A3.3.41 NP RESPONSE TO NRW REQUEST FOR ILLUSTRATIVE EXAMPLES OF AVIATION LIGHTING EFFECTS

Subject: RE: Y Bryn Wind Farm - Aviation Lighting scheme, VPs and ZTVs NRW:01273097

Y Bryn Wind Farm

Appropriate Noise Limits

Nordex N163 STE $L_{eq} = 109.2$
No CCVC
Blue = 40 dB L_{eq} Green = 35 dB L_{eq} Yellow = 30 dB L_{eq}

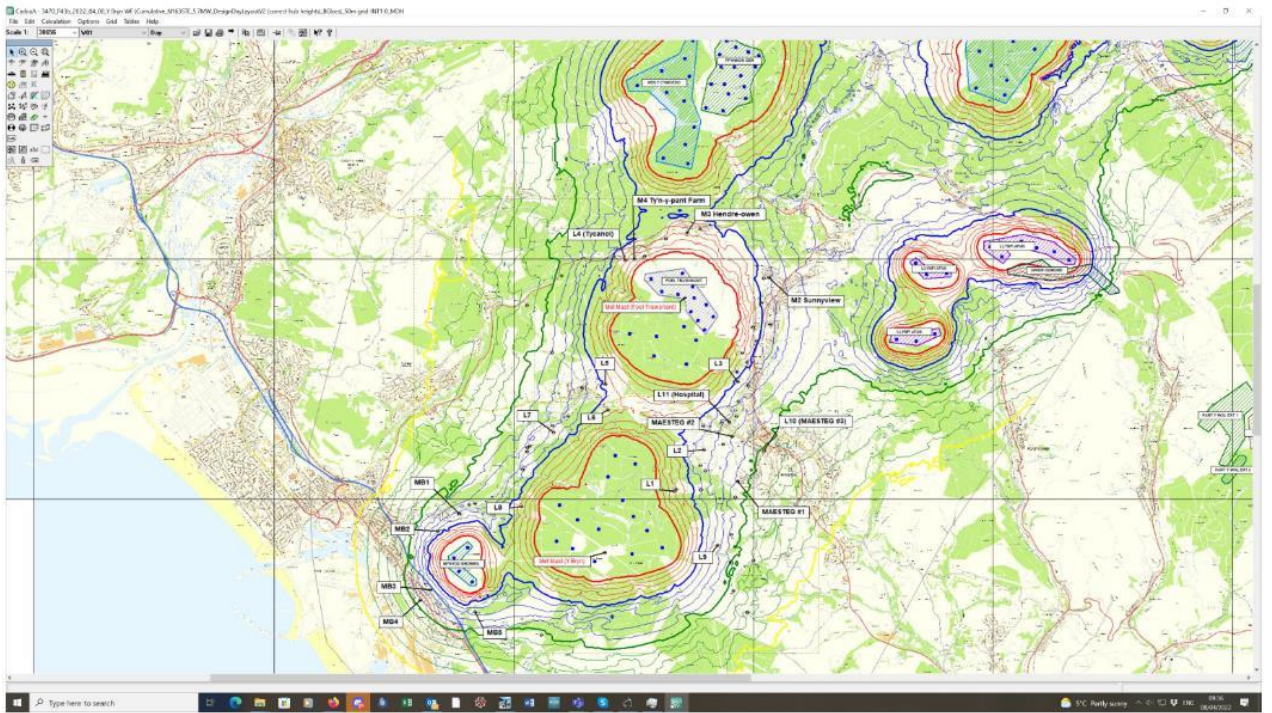
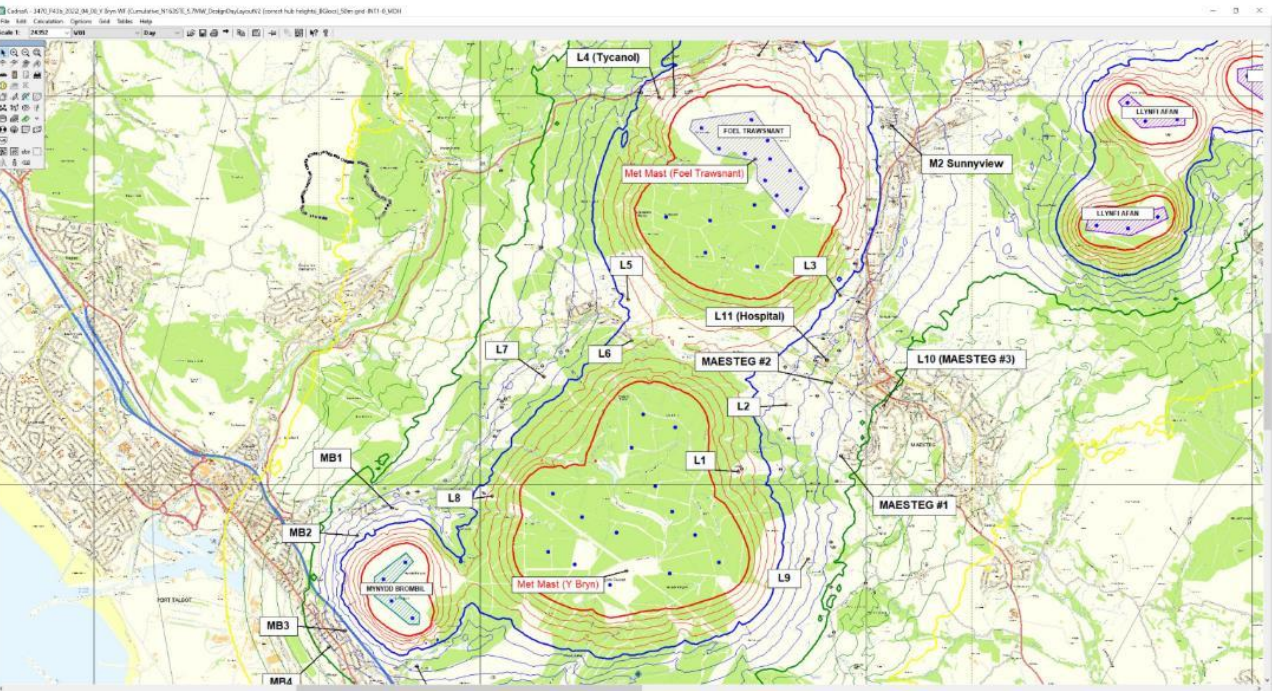
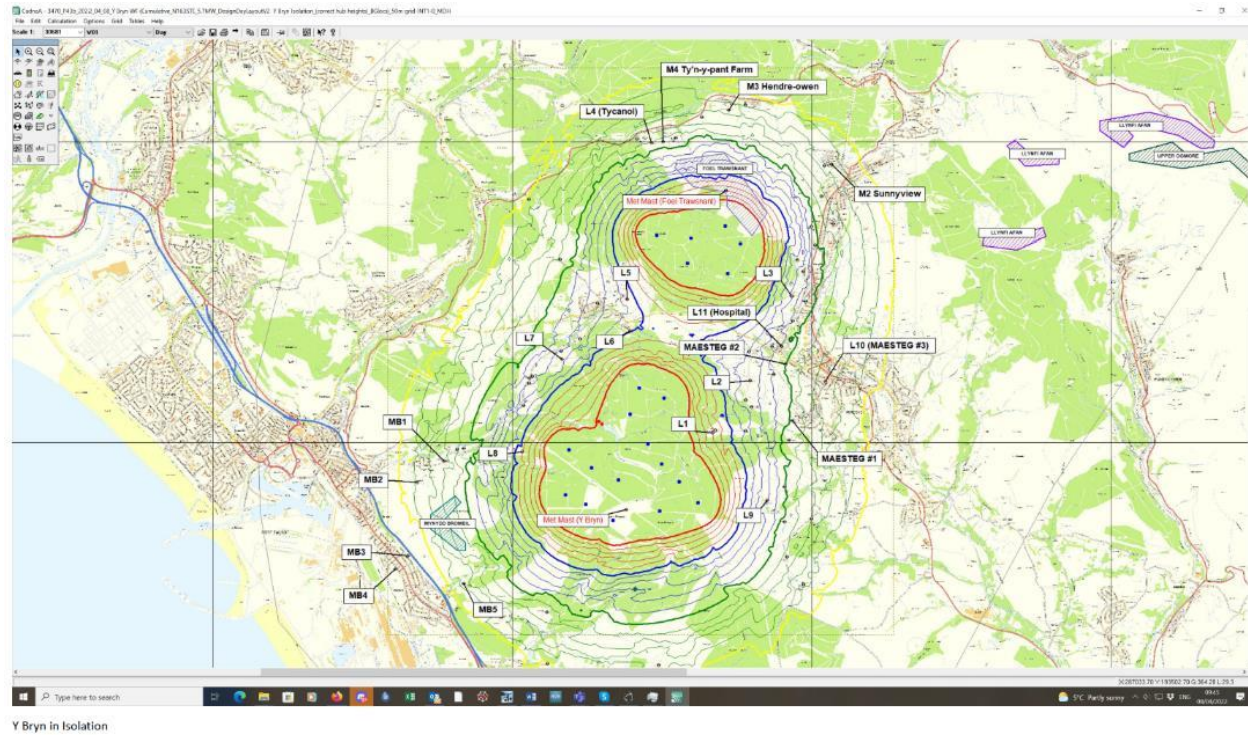
Following our meeting earlier this week it was requested that we provide some contour plots for the site both cumulatively and in isolation.

The source level we have assumed is $L_{WA} = 109.2$ dB, i.e. Published = $107.2 + 2$ dB

Encl. Y Bryn Wind Farm – Figure 15.2: Public Rights of Way

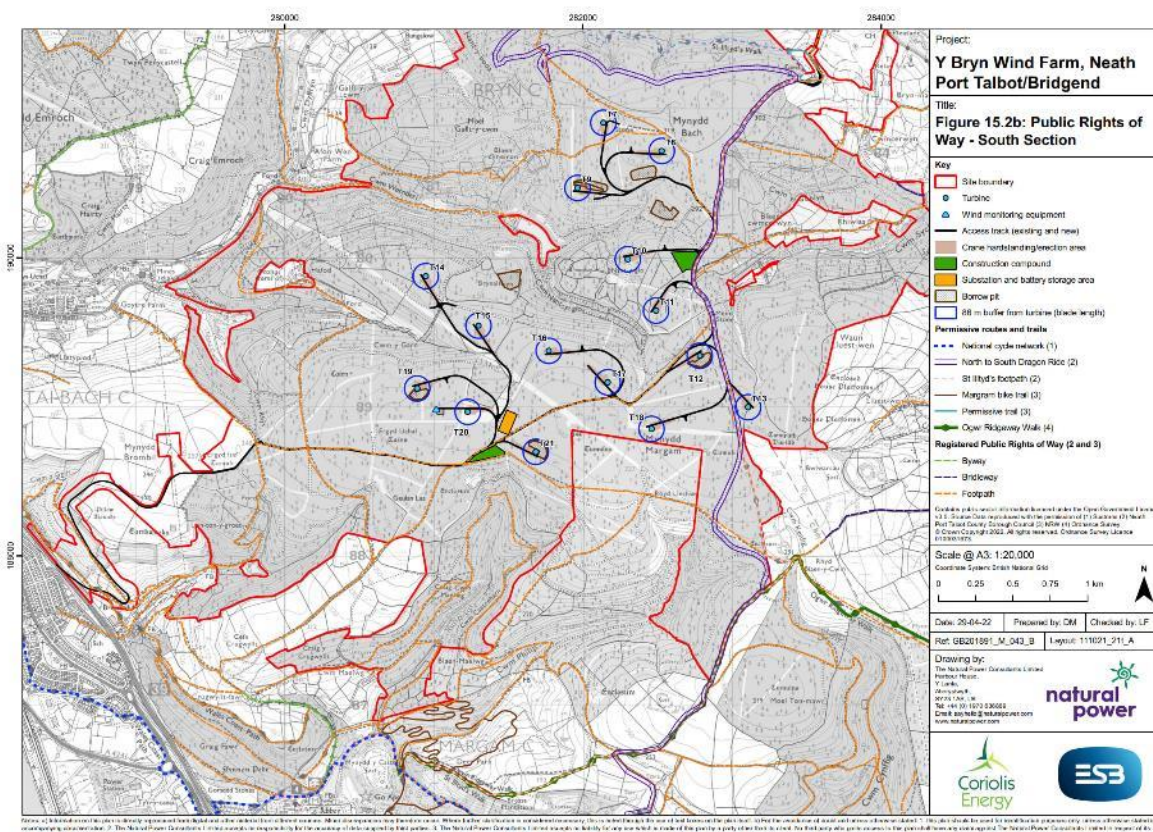
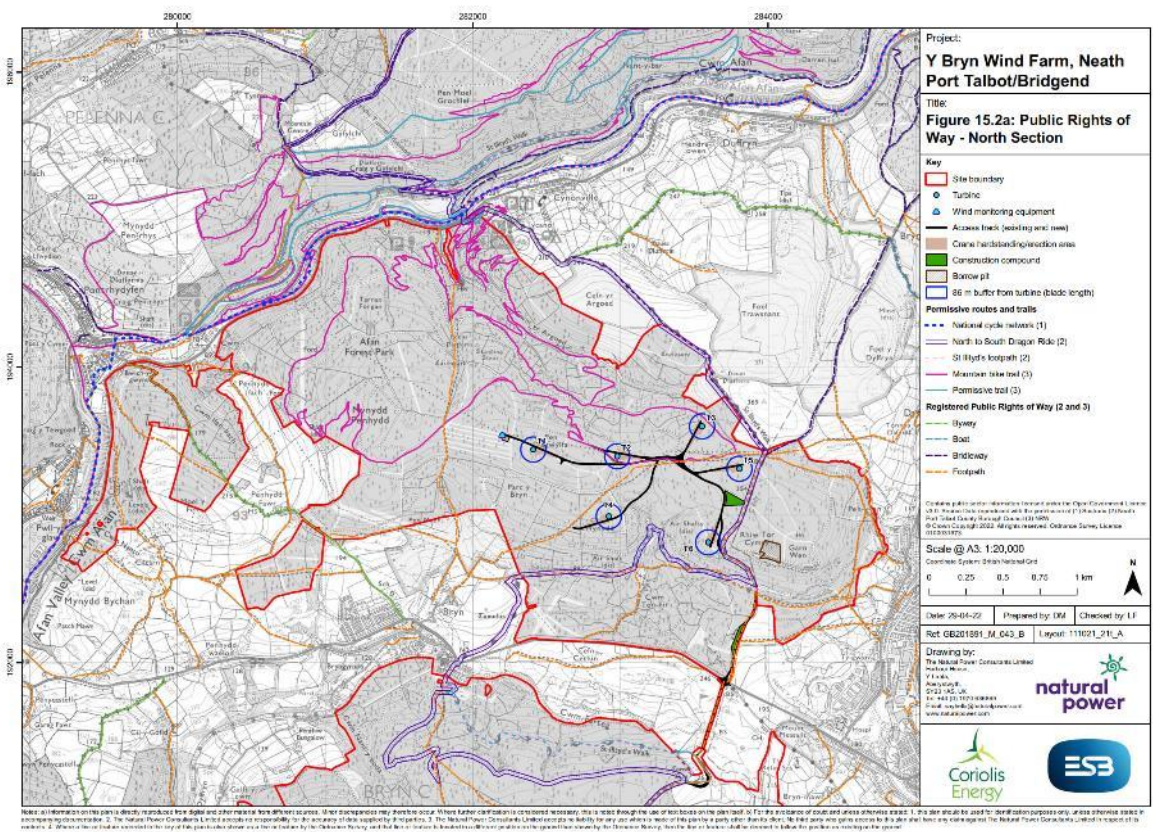
- The RoW Manager has asked for written confirmation of the maximum blade length of T13 and confirmation that no registered public footpath will be within the over-sail of a turbine.
- It is our belief that in p.2 of the letter the word “permitted” in the 4th line should be altered to either registered or Definitive to clarify that that is what is being referred to and not ‘permissive’ routes.
- Also on p.2 where the recorded permissive North to South Dragon Route is being referred to (line 8) we believe that “bridleway” should be inserted after “permissive” so that it is obvious that any proposed diversion then relates to this permissive bridleway and not the footpath over which it runs otherwise the public might query why other footpaths are not being diverted because they’re within the same distance from the turbines.
- The same would need to be changed on p.3
